UNITED STATES PATENT AND TRADEMARK OFFICE

APPLICATION NO.	FILING DATE	FIRST NAMED INVENTOR	ATTORNEY DOCKET NO.	CONFIRMATION NO.
10/696,463	10/30/2003	Ming-Tien Lin	HANP0022USA	6011
27765	7590	07/16/2007		
NORTH AMERICA INTELLECTUAL PROPERTY CORPORATION P.O. BOX 506 MERRIFIELD, VA 22116			EXAMINER RUDE, TIMOTHY L	
			ART UNIT 2871	PAPER NUMBER
			NOTIFICATION DATE 07/16/2007	DELIVERY MODE ELECTRONIC

Office Action Summary

DETAILED ACTION

FIG. 3E

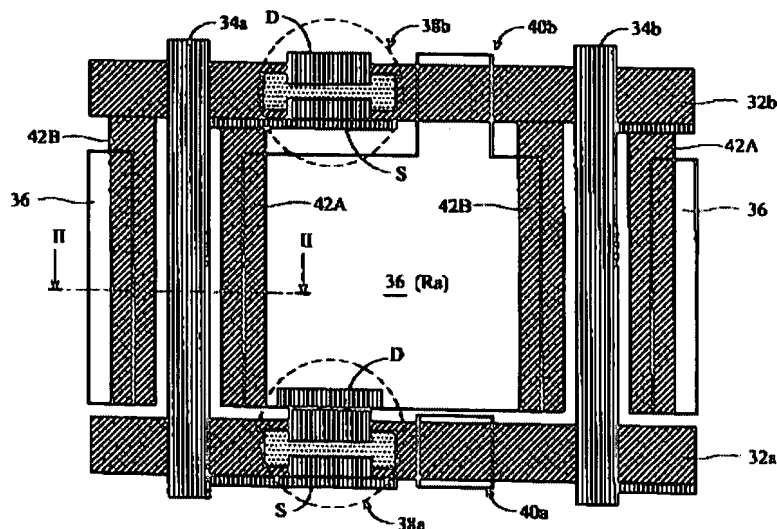
Newly added limitations as to "... overlaps across the source electrode of the thin film transistor of the adjacent pixel area." is considered misleading. Please reference Applicant's Figure 3E of the elected invention. 42A overlaps the extension portion of data line 34a that runs from 34a to the source of the TFT, 38b, at S. This is considered to be NOT the adjacent pixel area to the left of 34a at 42B and NOT above 32b.

Also, the first shielding layer does not overlap any source electrode.

Examiner understands what Applicant apparently wants to claim regarding 38b driving an adjacent sub-pixel, but the present claim limitations are still way too broad and misleading.

For examination purposes, "of the adjacent pixel area" will be considered to limit to - - any area adjacent the central portion of the pixel area - -. In other words, the peripheral area surrounded by 34a, 34b, 32a, and 32b.

Also, for examination purposes the shielding layer will be considered to overlap the extension portion connecting 34a to the source electrode at S, per Applicant's elected species, Figure 3E.

FIG. 3E

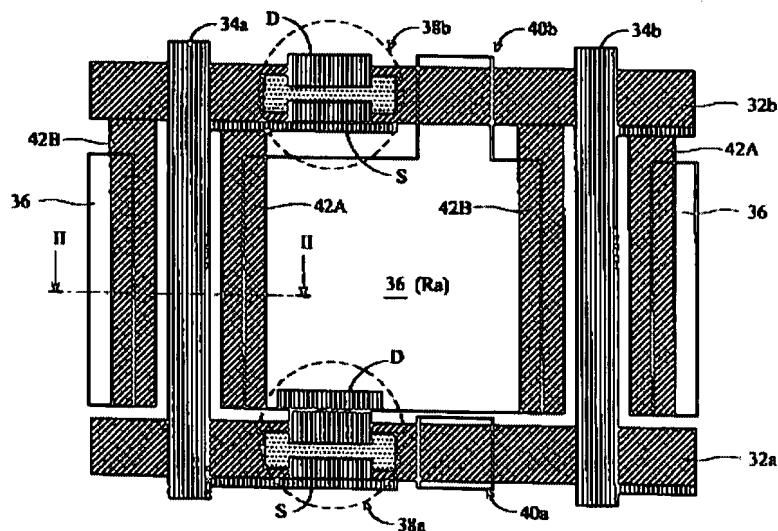
(1) It is respectfully pointed out that newly added limitations as to "... overlaps across the source electrode of the thin film transistor of the adjacent pixel area." is considered misleading. Please reference Applicant's Figure 3E of the elected invention. 42A overlaps the extension portion of data line 34a that runs from 34a to the source of the TFT, 38b, at S. This is considered to be NOT the adjacent pixel area to the left of 34a at 42B and NOT above 32b.

Also, the first shielding layer does not overlap any source electrode.

Examiner understands what Applicant apparently wants to claim regarding 38b driving an adjacent sub-pixel, but the present claim limitations are still way too broad and misleading.

For examination purposes, "of the adjacent pixel area" will be considered to limit to - - any area adjacent the central portion of the pixel area - -. In other words, the peripheral area surrounded by 34a, 34b, 32a, and 32b.

Also, for examination purposes the shielding layer will be considered to overlap the extension portion connecting 34a to the source electrode at S, per Applicant's elected species, Figure 3E.
